**COLORADO**  
Division of Reclamation,  
Mining and Safety  
Department of Natural Resources

**RE: Adequacy Review, 112 Construction Materials Amendment (AM-01); Raindance Reservoir #2, DRMS File No. M-2021-049**

CONSTRUCTION MATERIAL SPECIAL 112 OPERATION RECLAMATION - EXHIBIT F (RECLAMATION PLAN MAP)

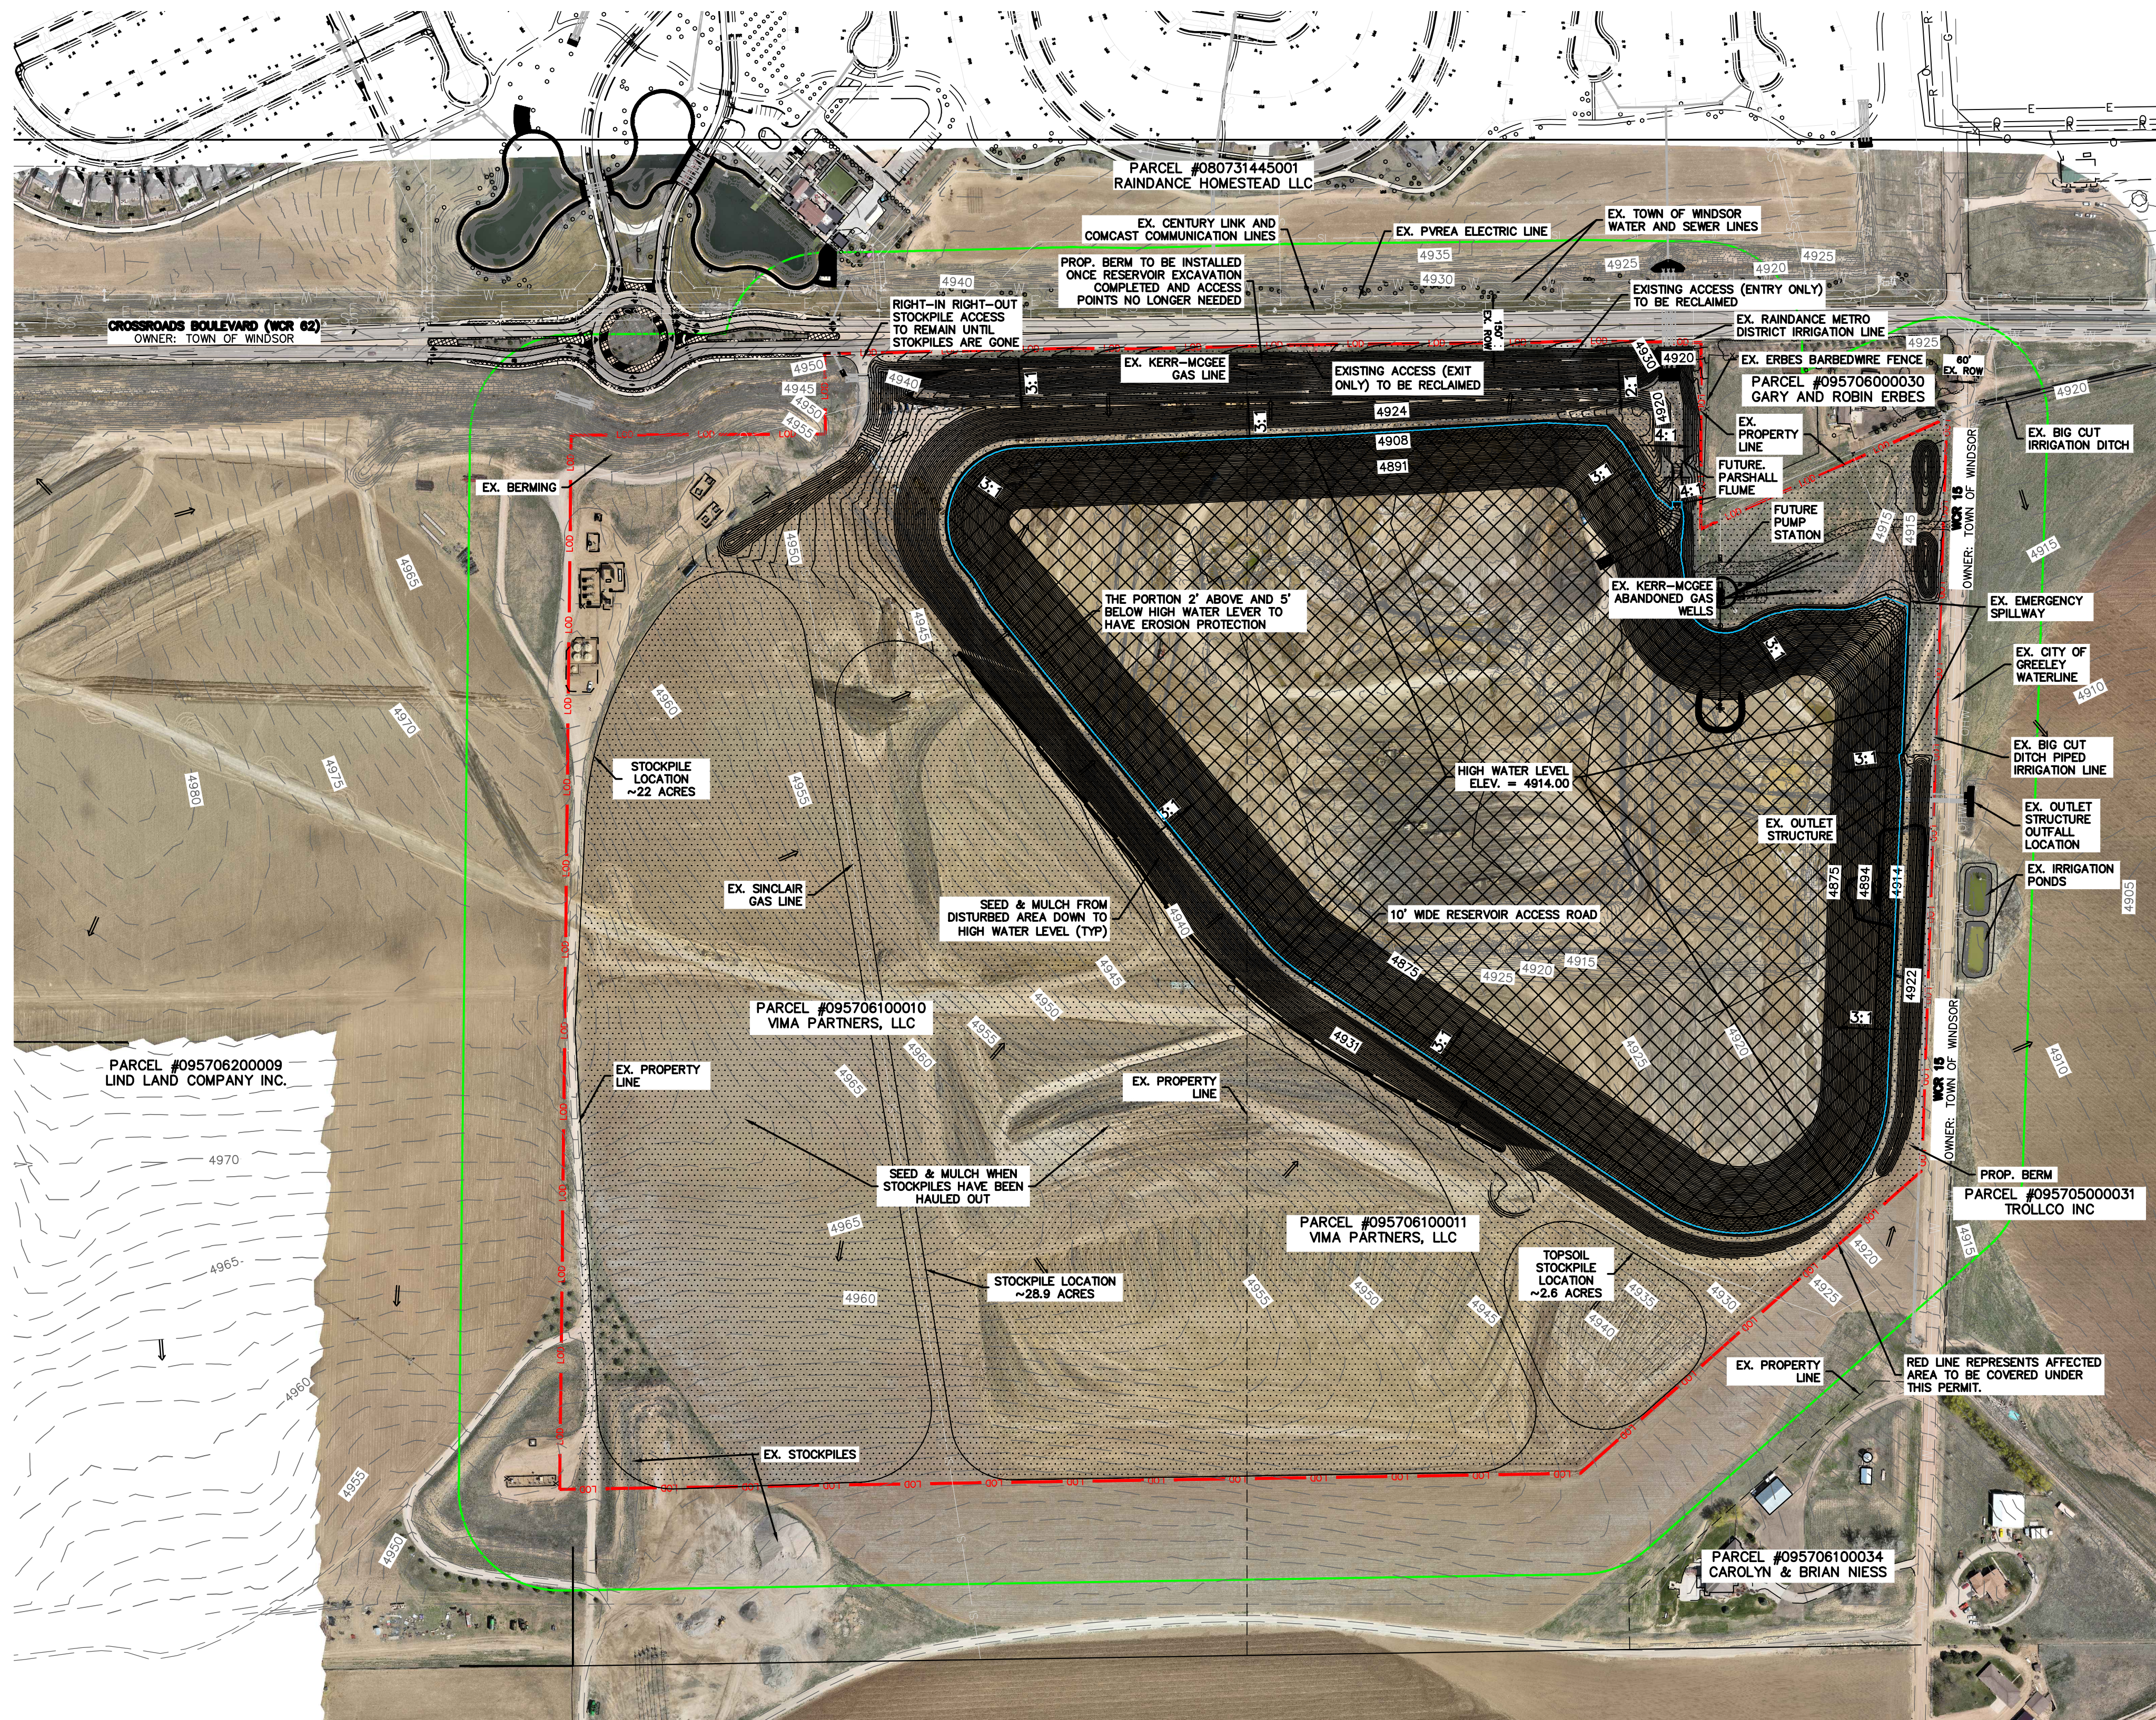
10. Reclamation cost information will need to be updated to provide more specific estimates on the cost of tasks associated with this operation. The types of equipment used to conduct reclamation tasks will also need to be listed. Common reclamation tasks include: backfilling, grading, topsoil application, seeding, mulching, fertilization, and labor. If possible, please also list the cost per unit of each of the listed tasks, e.g. grass seed mix and seed and tree replacement.
11. The Reclamation Plan Map shows that the currently existing topsoil pile will be moved from the west to the south end of the operation and occupy an ~ 2.6 acre footprint. Please provide justification in the form of calculations that enough topsoil will be available on

site to replace 4 inches of depth across the potential 86 acres of disturbed land which would need to be reseeded.

THE TOTAL RECLAMATION AREA (EXCLUDING RESERVOIR) IS APPROX. 86 ACRES AND AT A TOPSOIL DEPTH OF 4 INCHES THE VOLUME WOULD BE APPROX. = 46,245 CY. THE FOOTPRINT OF THE TOPSOIL STOCKPILE IS 2.6 ACRES AND IT IS 22' TALL PROVIDING APPROXIMATELY 60,000 CY OF TOPSOIL.
